**REPORT  
OF THE  
OPERATIONAL SAFETY REVIEW TEAM  
(OSART)  
MISSION  
TO THE  
GOLFECH  
NUCLEAR POWER PLANT  
FRANCE  
10-27 October 2016  
AND  
FOLLOW UP MISSION  
13-17 May 2019**

**DIVISION OF NUCLEAR INSTALLATION SAFETY  
OPERATIONAL SAFETY REVIEW MISSION  
IAEA-NSNI/OSART/190F/2019**

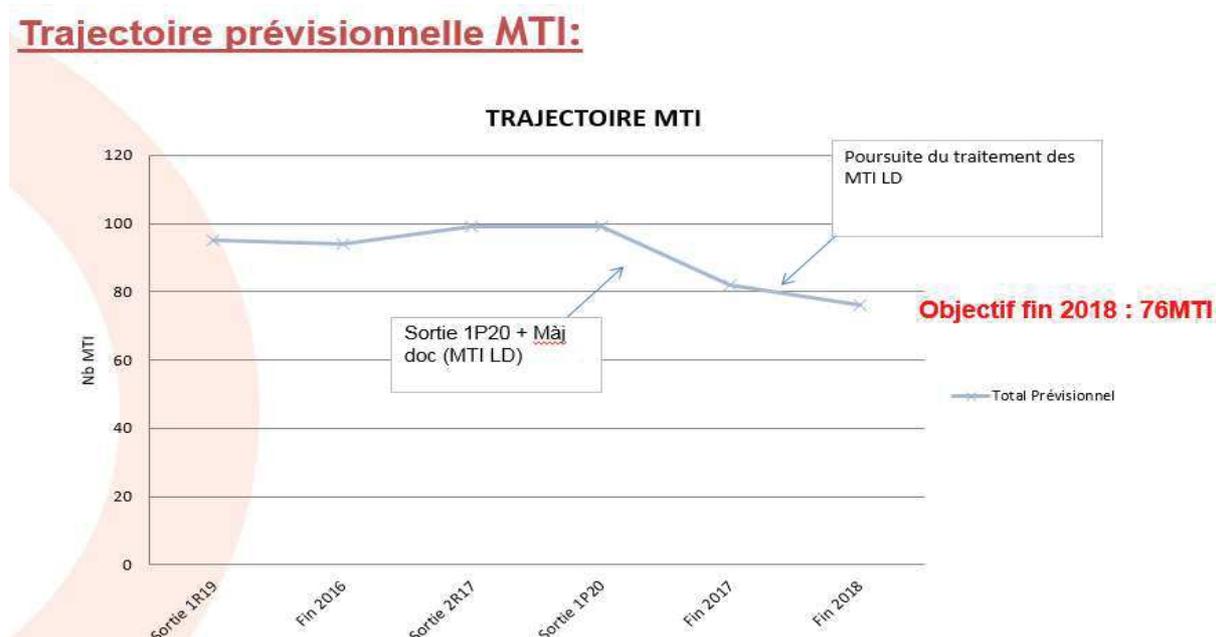
- Priority 3 of the site's 2019 performance agreement identifies the need to adapt our organisations to place the integration of modifications on a secure footing (MP8 objective). This objective is broken down into two targets:
  1. Adapt processes and organisations for handling external requirements and modifications to absorb the workload due to the major plant refit and ten-yearly outage programmes.  
=> Progress: 20%.
  2. Integrate and execute the 2019 programme of external requirements and modifications.  
=> Progress: 10%.

The progress of these two actions is tracked in the CAMELEON application.
- New indicators are currently being developed, with a new tracking table for modifications (use of BI reports from the information system).
- Work is under way with the departments to deal with delays in integration.

## 8.2 (a) Good Practice: On-line stator cooling system purification and cleaning

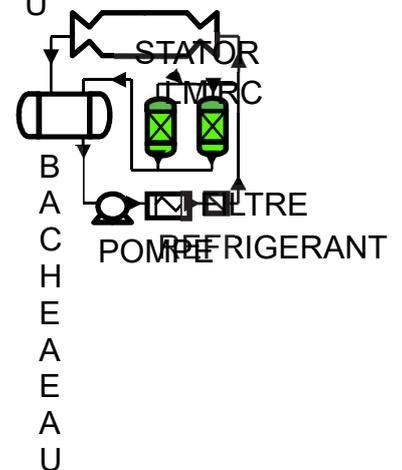
In contrast, station chemists and operators use a two-stage process using existing plant equipment, air and pH adjustments that supports a controlled on-line cleaning without the need for adding chemicals.

1. **Acidification** : a cationic resin is used on its own.  $\text{Cu}^{2+}$  ions are retained and exchanged with  $\text{H}_3\text{O}^+$  ions, which decrease pH (acid pH). Acid pH makes the  $\text{CuO}$  copper oxides soluble.

2. **Purification** : a mixed-bed resin is used joint with the cationic resin in order to clean the stator cooling fluid.
